TOWN OF  
**NORTH KINGSTOWN, RHODE ISLAND**

**May 4, 2016**  
**ADDENDUM #2**

**INVITATION FOR BIDS**  
**BOAT RAMP, ALLEN HARBOR**

# Geotechnical Investigation Executive Summary

**FIGURE 1: Boring location**

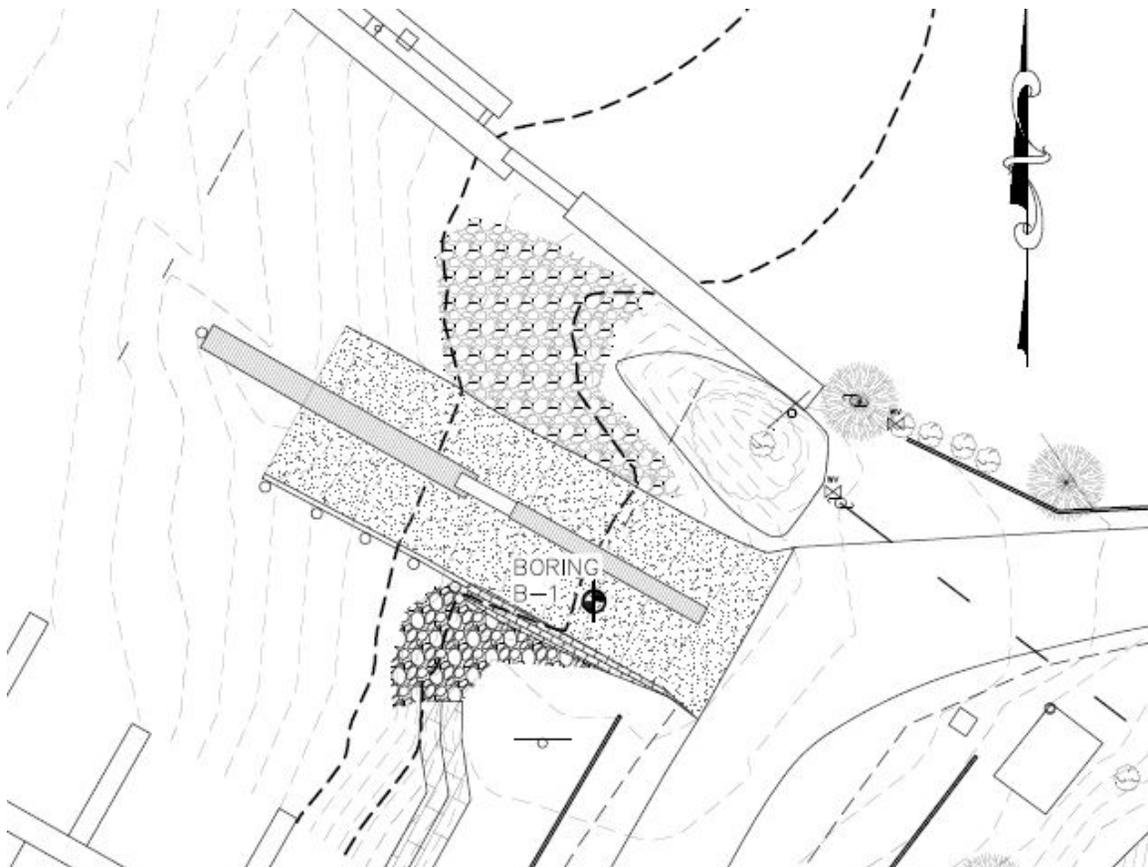
The location of the single proposed boring was chosen to be accessible by a truck mounted drill rig and within the footprint of the proposed ramp. *ALLSTATE DRILLING CO (ALSTATE)* utilized a truck-mounted drill rig to identify subsurface strata and retrieve samples for soil identification. The exact location of the boring was moved to a spot in the ramp that did not have any concrete on the surface for ease of drilling. The concrete

At the boring location, an auger was drilled in 5 ft increments into the subsurface material by the drill rig. Once the auger was drilled to a depth of 5 ft, a 2” diameter split spoon sampler was then driven using the *Standard Penetration Test (SPT)* beginning at the bottom of the auger and driven a total of 2 ft (or to refusal) and used to retrieve material samples. The driller recorded the ‘blow counts’ (the number of hammer drops onto the top of the sampler **SPT<sub>n</sub>**) in four (4) six-inch increments. The density/resistance of the soil and other properties can be estimated by the contractor and his engineer using the **SPT<sub>n</sub>** and the driller’s description of the soil. This information is necessary to properly design a cofferdam and dewatering plan.
